Access Compliance Report

Public Rights-of-Way

(Curb Ramps)

Intersection ID: 48767	Main Street: TURNING_WHEEL_DR	Cross Street: MINITREE_LN	Location: NE
ADA ID: FA66B11C4892	Ramp Type: PerpDiag	Initial Pass/Fail: Fail	Overall Compliance: No
Severity Score: 10			
Codes/Mitigation Info/Possible Solution		Field Measurements/Component Compliance

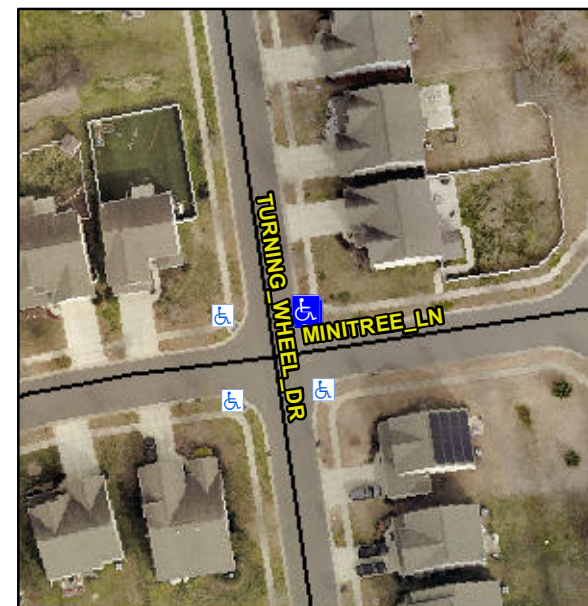
Not Found, R304.5.1, R304.5.3

Compliance	Description	Data	Compliance	Description	Data
N/A	Ramp Length (in)	73.0	Yes	Ramp Slope (%)	5.4
No	Ramp Width (in)	47.0	No	Ramp XSlope (%)	2.6
N/A	Flare Type LT	N/A	N/A	Flare Type RT	N/A
N/A	Flare Slope LT (%)	N/A	N/A	Flare Slope RT (%)	N/A
N/A	Flare Traversable LT?	N/A	N/A	Flare Traversable RT?	N/A
N/A	Landing Length (in)	N/A	N/A	DWS Provided?	N/A
N/A	Landing Width (in)	N/A	N/A	DWS Contrast?	N/A
N/A	Landing Slope (%)	N/A	N/A	DWS Length (in)	N/A
N/A	Landing X Slope (%)	N/A	N/A	DWS Full Width?	N/A
N/A	Landing Curb? (Y/N)	N/A	N/A	DWS Offset (in)	N/A
N/A	Shared Landing?	N/A			
N/A	Gutter Ponding?	N/A	N/A	Gutter Slope (%)	N/A
N/A	Gutter Lip Ht (in)	N/A	N/A	Gutter X Slope (%)	N/A
N/A	Painted X Walk1?	No	N/A	Painted X Walk2?	No
	X Walk 1 Direction	To W		X Walk 2 Direction	To S
N/A	X Walk 1 Width (in)	N/A	N/A	X Walk 2 Width (in)	N/A
	X Walk 1 Slope (%)	0.3		X Walk 2 Slope (%)	0.7
	X Walk 1 X Slope (%)	1.0		X Walk 2 X Slope (%)	2.1

Remove & Replace Curb Ramp With Two New Directional Ramps or Equivalent.
